HARTZELL PROPELLER INC.
SERVICE BULLETIN
HC-SB-61-389

Pitch Change Knob Brackets/Mounting Hardware

Safety Wire: 3-blade Propellers
Figure 1

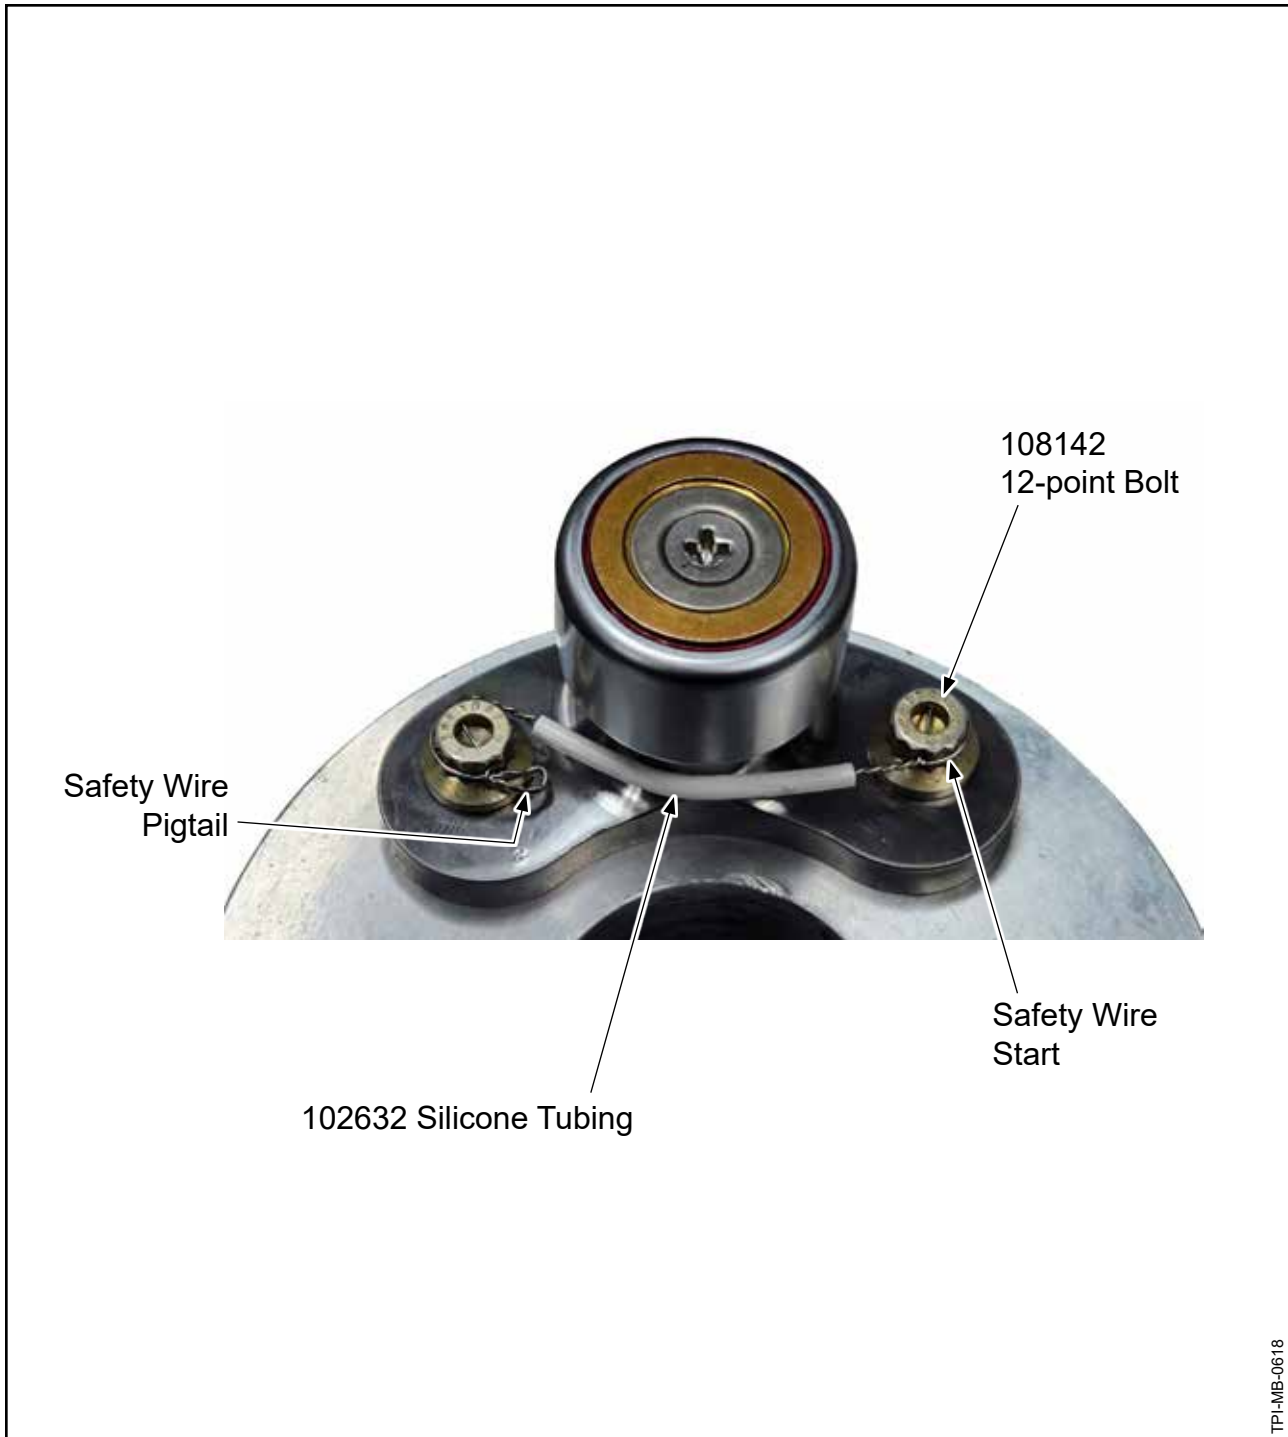
- 4 Safety wire the 108232 hex head bolts to the hole in the pitch change knob bracket in accordance with NASM33540 and Figure 1.
 - 5 Repeat steps (4)(a)1 thru (4)(a)4 of this procedure for the remaining blades.

- 3 Attach the 108305-() pitch change knob bracket to the butt of the blade with two 108232 hex head bolts.
 - a Torque the 108232 hex head bolts 16-18 Ft.-Lbs. (22-24 N•m).
